# **Pentium<sup>®</sup> II Processor Specification Update**

Release Date: December 1997

Order Number: 243337-008

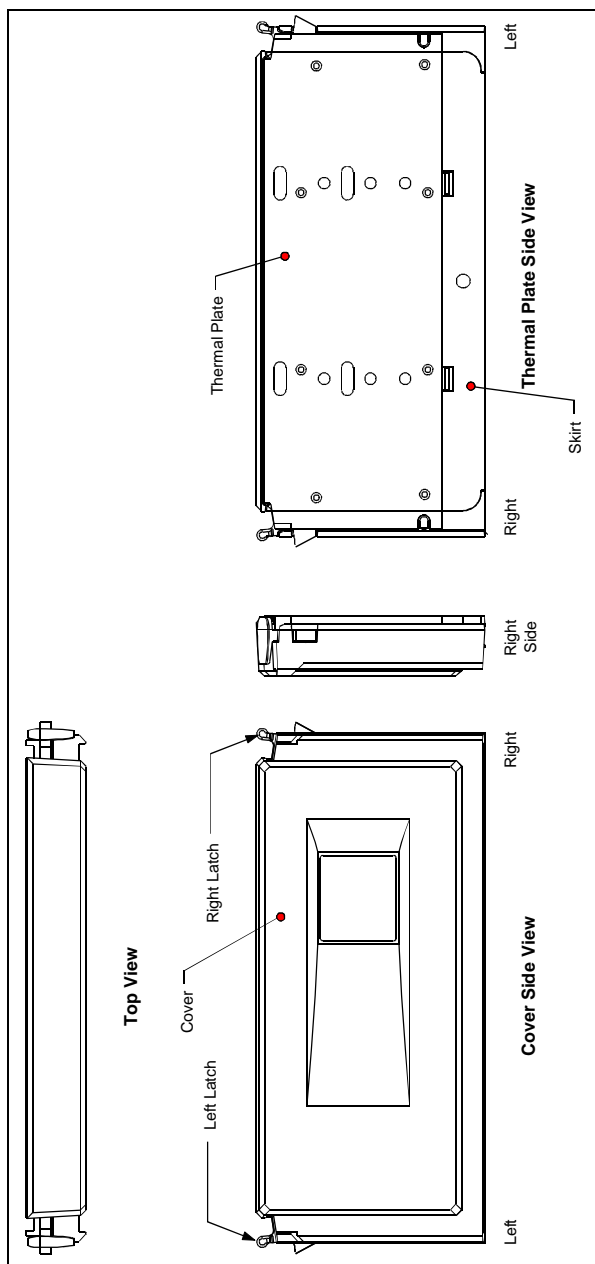
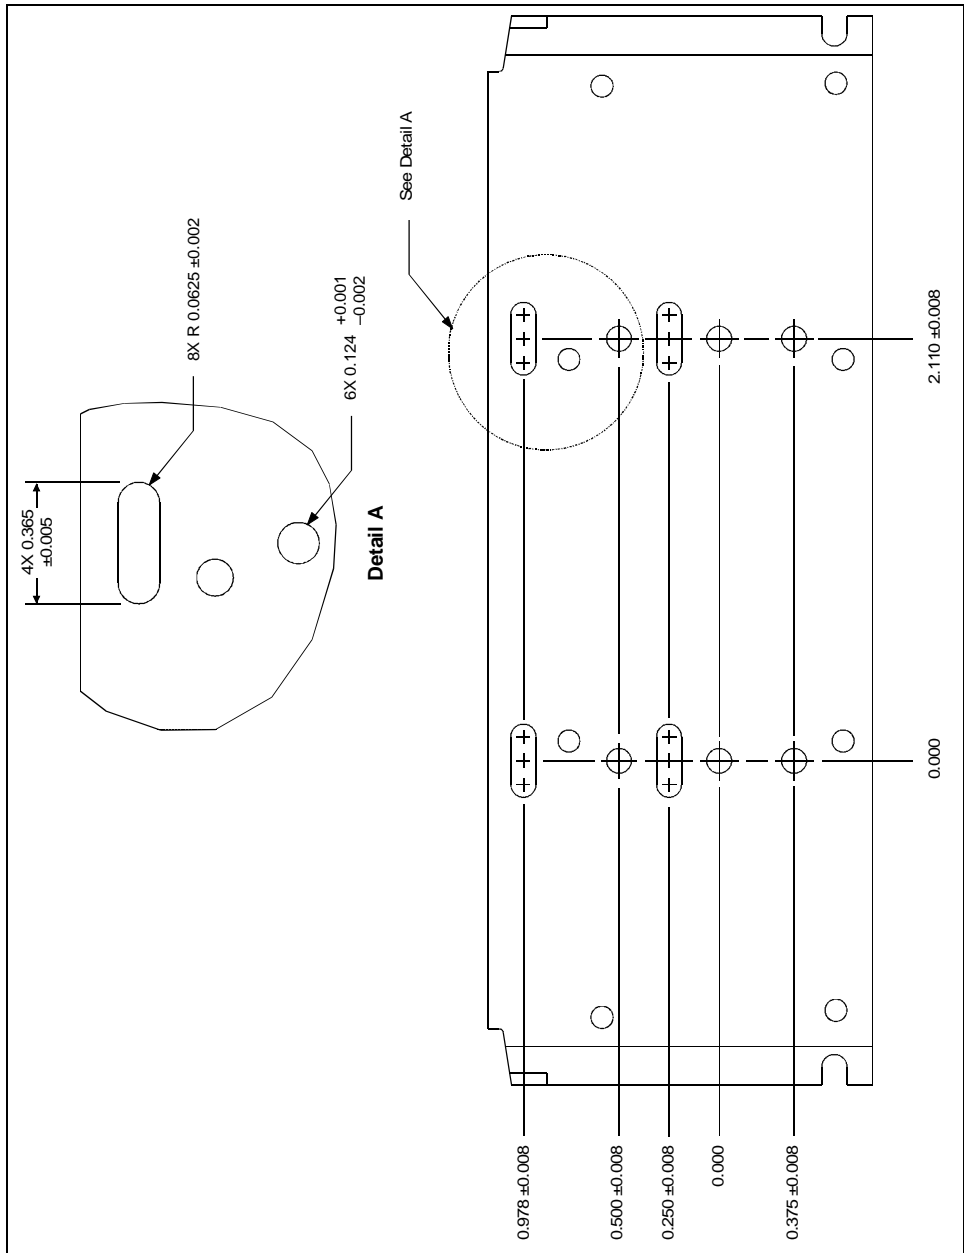
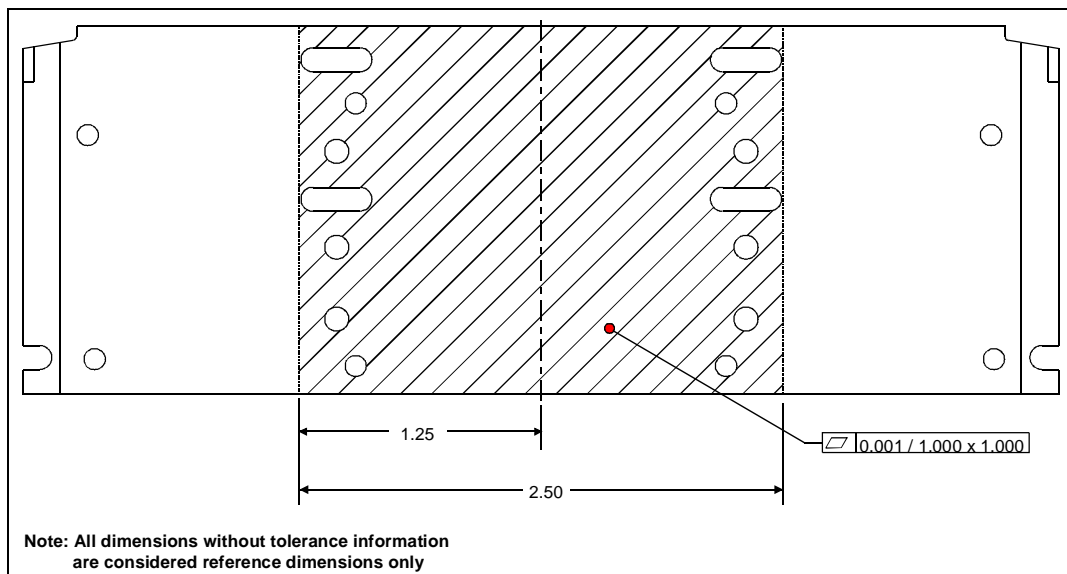
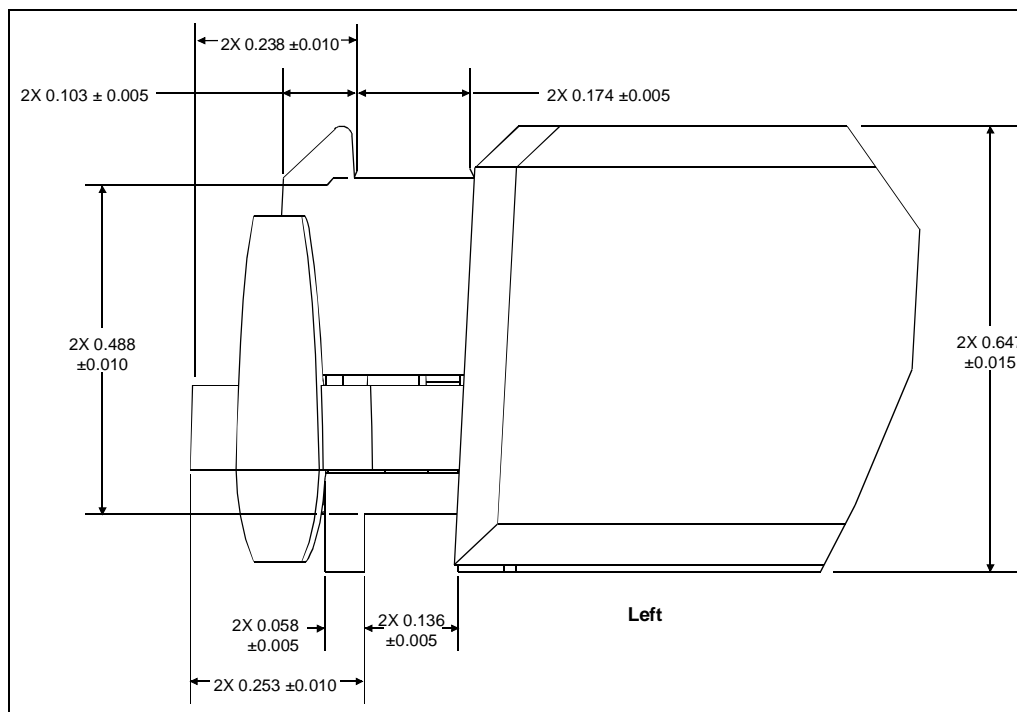
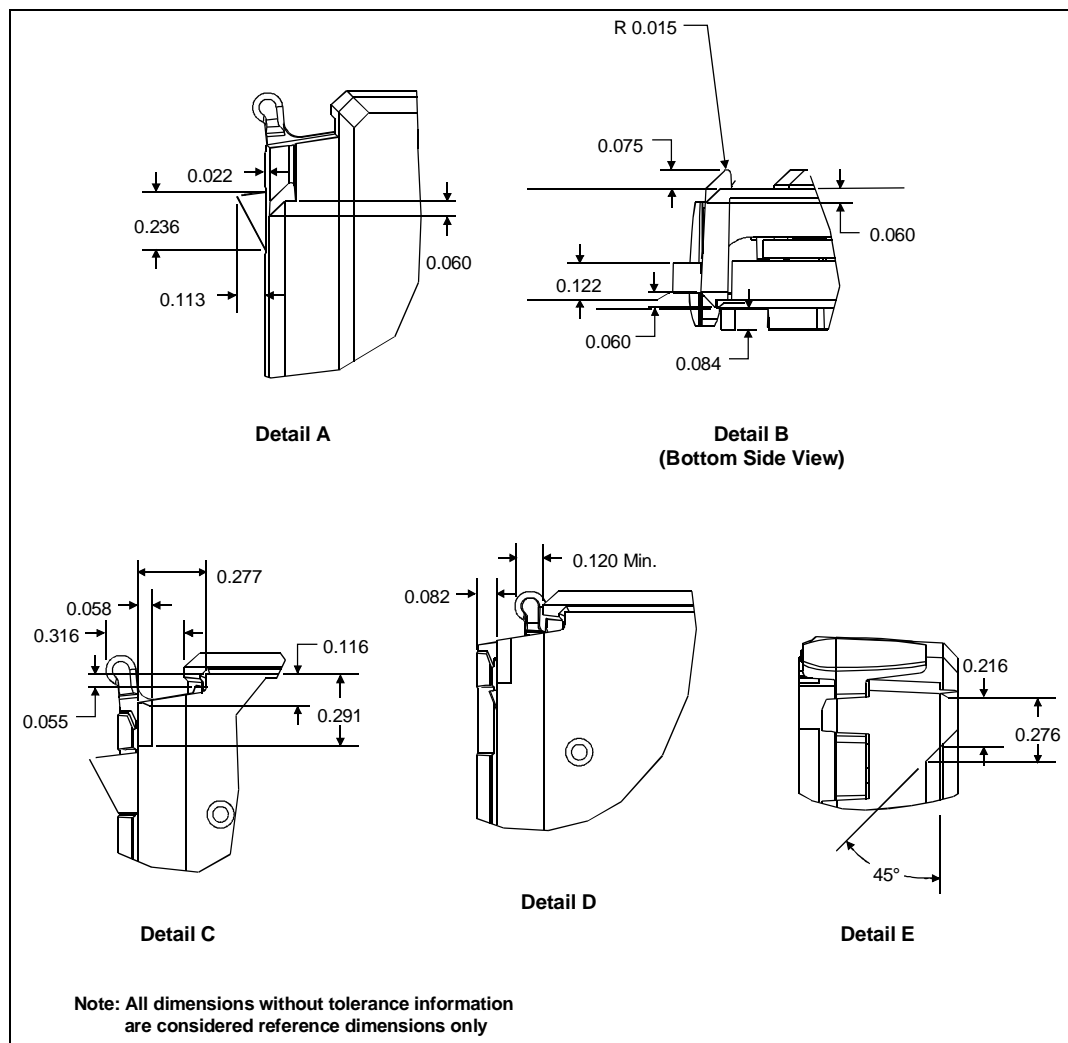
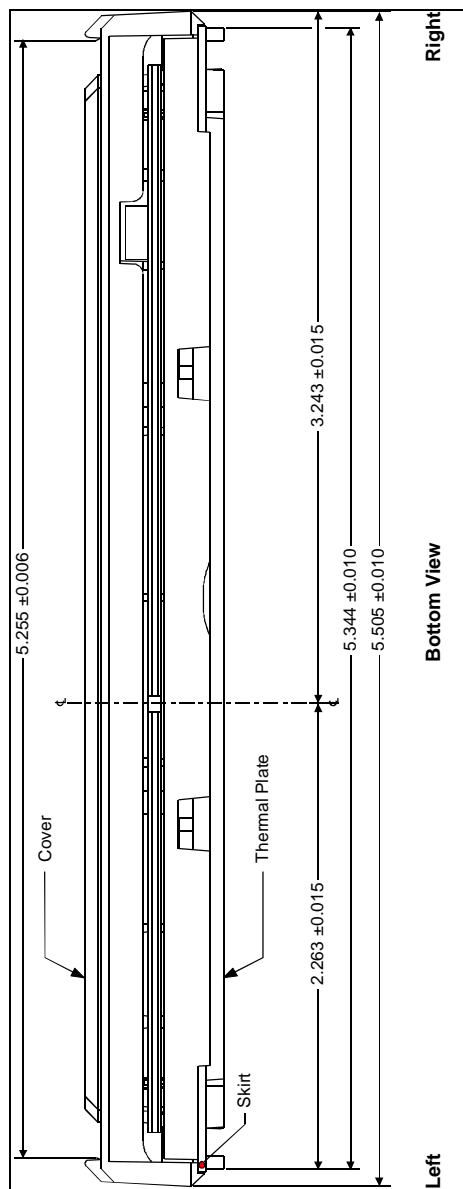
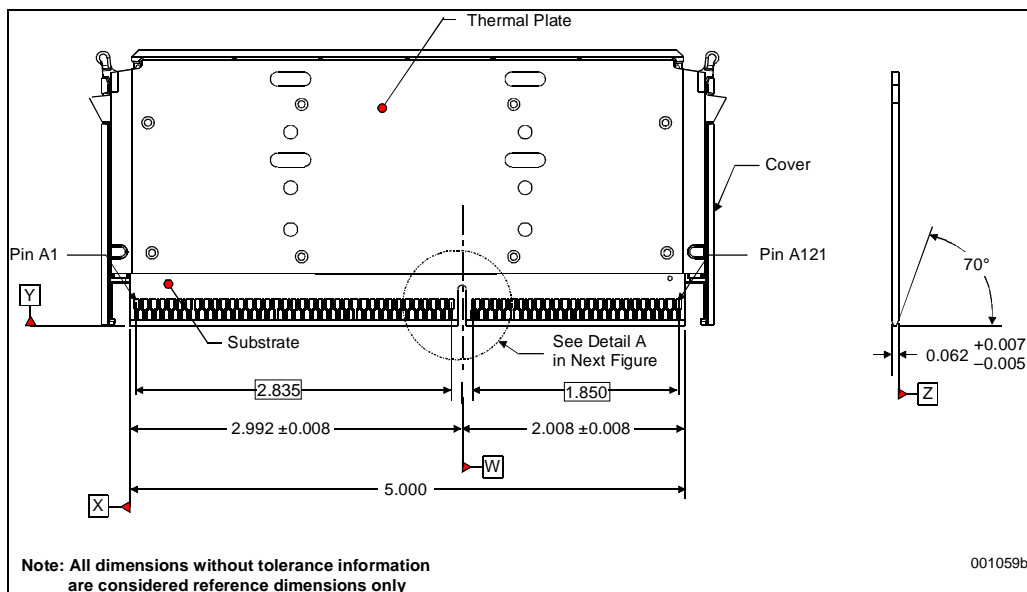
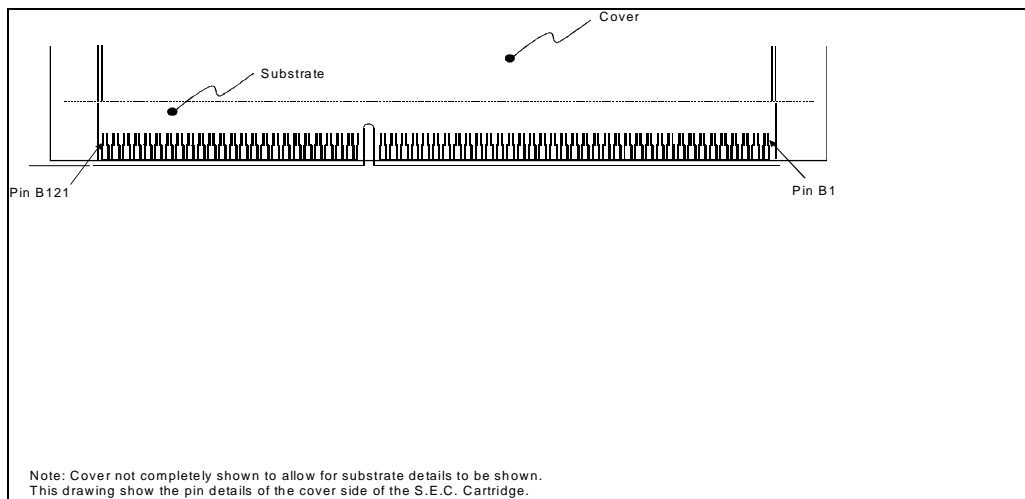
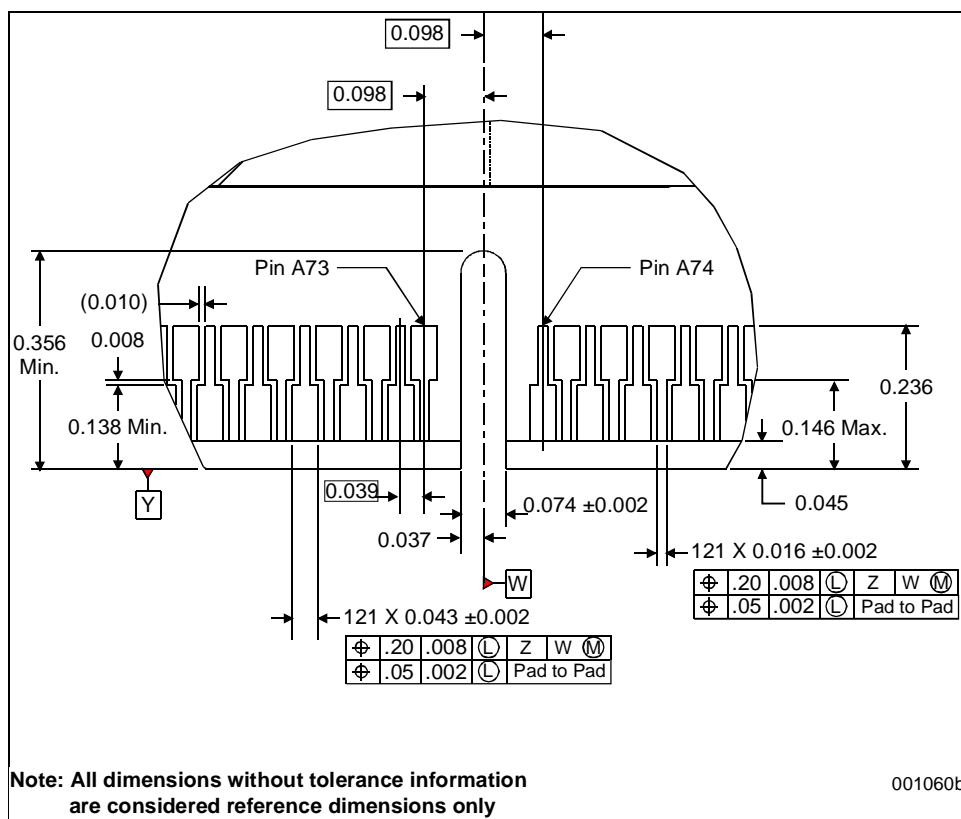
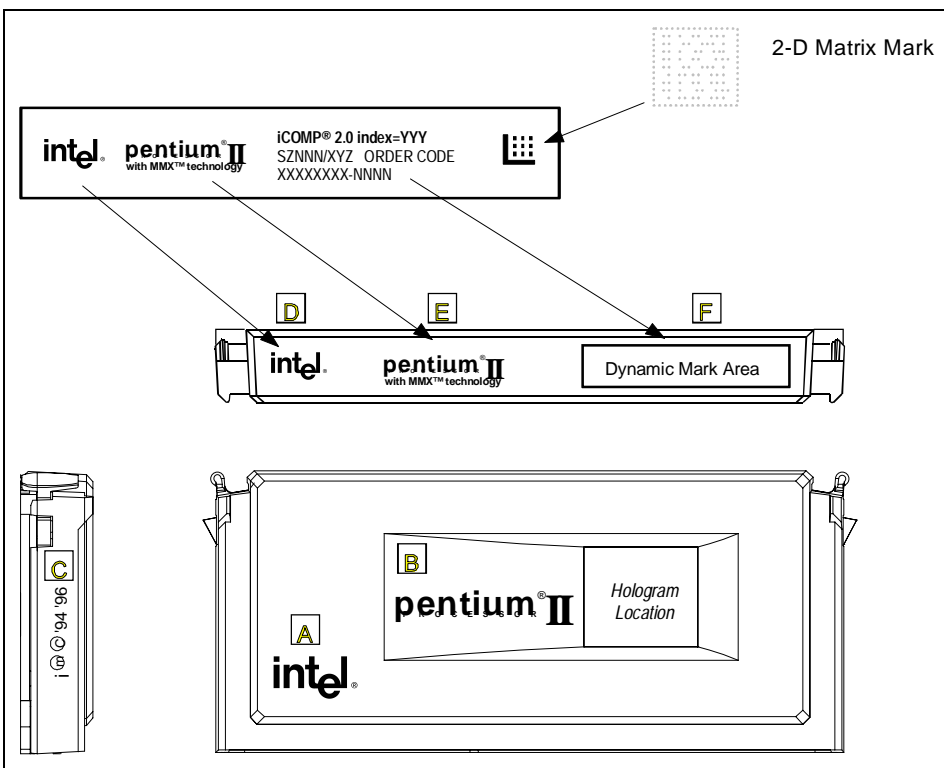
The S.E.C. cartridge mechanical specifications provided in the *Pentium® II Processor at 233 MHz, 266 MHz and 300 MHz* datasheet contained incorrect tolerance information for some dimensions. Also, some of the information provided in the figures was duplicitous and not required to accurately use and design for the S.E.C. cartridge package. The revised figures provided in this section are meant to replace Figures 29 through 42, Table 23 and the accompanying notes found on page 44.

**Figure 12. Heatsink Attachment Mechanism Design Space**

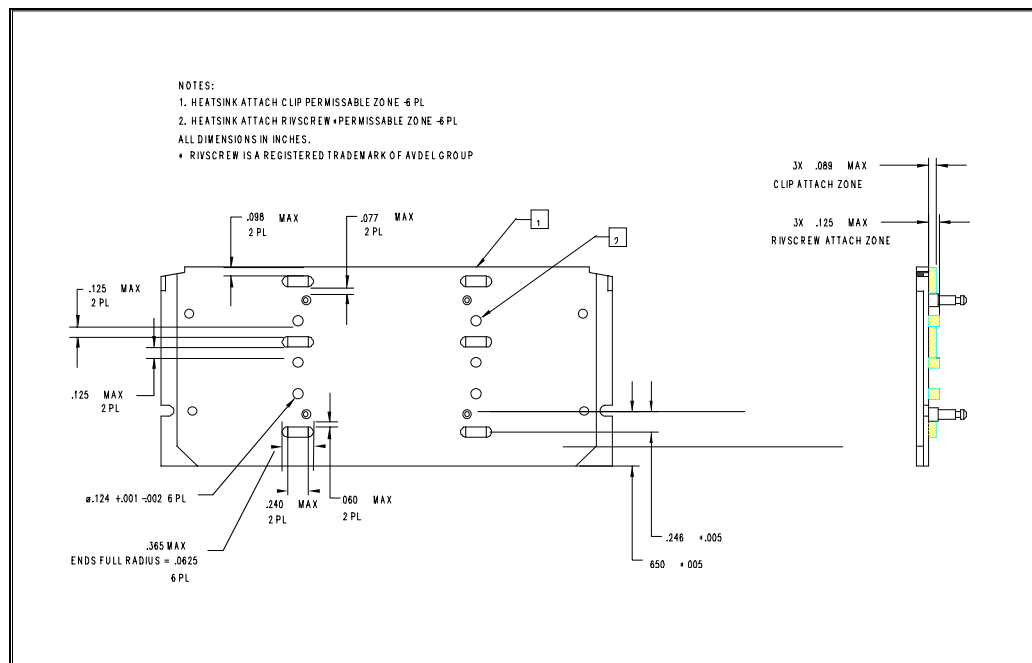
A change to the attach mechanism specification is provided below. The original specification for clearance of heatsink attach solutions is provided in Section 4.3 (and Figure 23 and Figure 24) in the *Pentium® II Processor at 233 MHz, 266 MHz and 300 MHz* datasheet. Figure 11 shows the revised maximum specifications for heatsink clip and RivscREW\* attach mechanism designs. All heatsink clip and RivscREW attachment solutions must remain within the respective maximum “permissible” zone as detailed in Figure 11.

The thermal plate shown in Figure 11 is used to portray the heatsink attach mechanism design space for the future Slot 1 processors. However, the maximum “permissible” design space is also valid for both the current Pentium II and future Slot 1 processors.

Please review the proposed specifications to guarantee compatibility with existing Pentium II and future Slot 1 processor heatsink attachment solutions. Note that the required heatsink attachment solution space should not exceed the maximum proposed design space while installed or during the installation and removal procedure.
